# Downtown Design Review

Project Name: Spoon Building – Shell Improvements  
Project Address: 118 Cherry Street NE  
Project File Number: 21-3463  
Applicant: Tom Rieger, AIA, Thomas Architecture Studios

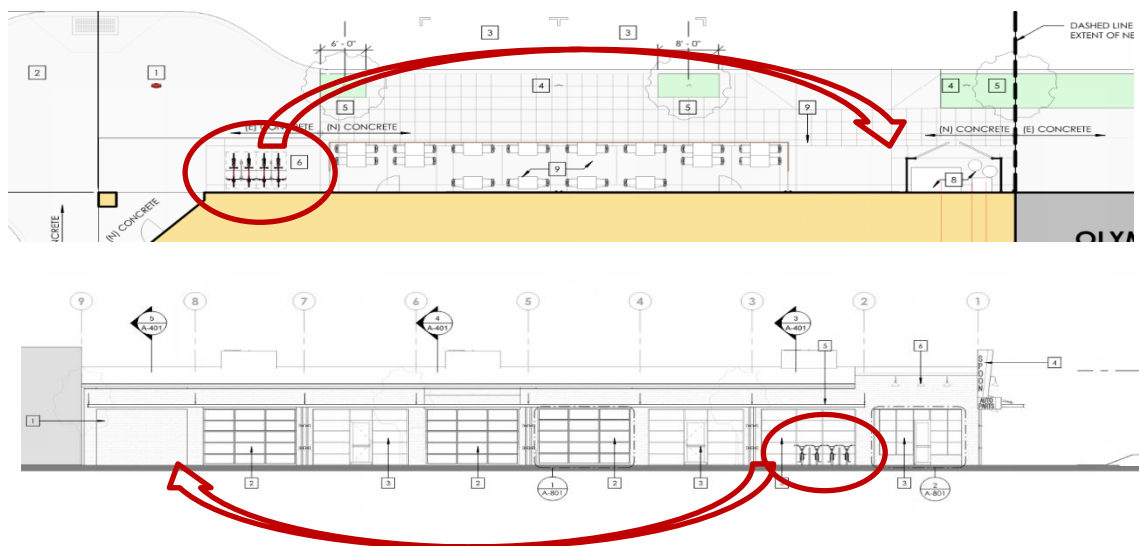
Short-term bike parking is shown located in front of the building along State Avenue just east of the front entry. The location of the bikes could pose a circulation problem as pedestrians walk around the corner on Cherry Street or onto State Avenue. There may be a better location for the bikes such as between the eastern edge of the seating area and the enclosed solid waste structure (see graphic below), or one of the bike racks could be located on the Cherry Street frontage and one on State Avenue under canopy, or the bike parking as it’s located now could be shifted east a few feet (up to 5 feet) to provide more space for pedestrians along Cherry Street and for those entering through the main entrance.

Floor plans were not provided because a specific tenant has not been identified for the project, so it’s difficult to tell whether building structural elements preclude bike parking from being located elsewhere. The requirement is met with the bike parking location as-is, but the design team should be prepared to discuss the topic with the Board prior to detail design recommendation. The Board may want to make a recommendation for a different location of short-term bicycle parking – any motions to this effect should be prepared and provided at the meeting.

Figure 18.120.260.B.1: Examples of how to screen roof-mounted mechanical equipment.

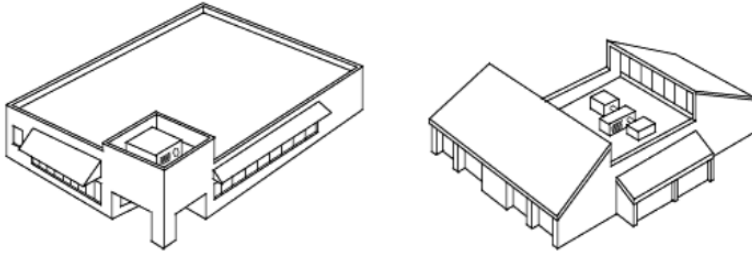
The solid waste enclosure may be located at the sidewalk outside the building, as mentioned by the applicant above. The architectural packet includes specifications of a black aluminum fence system that will provide full screening from the sidewalk (staff provided a photo of this type of screening). Existing mechanical equipment located on the roof will be replaced with new HVAC equipment and according to the elevation legend on Sheet A-902 the rooftop equipment may not be screened. Screening of rooftop equipment is required and should be screened on all sides from surrounding sidewalks and from higher elevations nearby.

- Roof-mounted mechanical equipment shall be located and screened on all sides, so the equipment is not visible from the ground level of any street, sidewalk, or adjacent property within 20 feet of the structure. The color of roof mounted equipment shall match the exposed color of the roof to minimize visual impacts when equipment is visible from higher elevations nearby.

(A) FLOOD GATE STANDARD - ADJUSTED FROM REAR OF PRODUCT (Shown without neoprene cover)

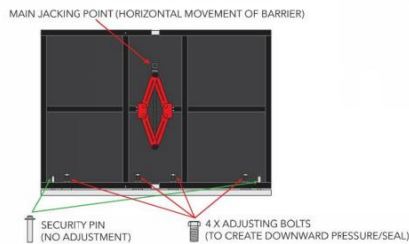
**STAFF RESPONSE:** Project improvements include the use of most of the existing materials, including exposing the concrete building shell. The architectural plan set indicates there will be flood proofing and provides photos and cut sheets of the type. The design team should explain to the Board how and where the flood proofing will be installed.
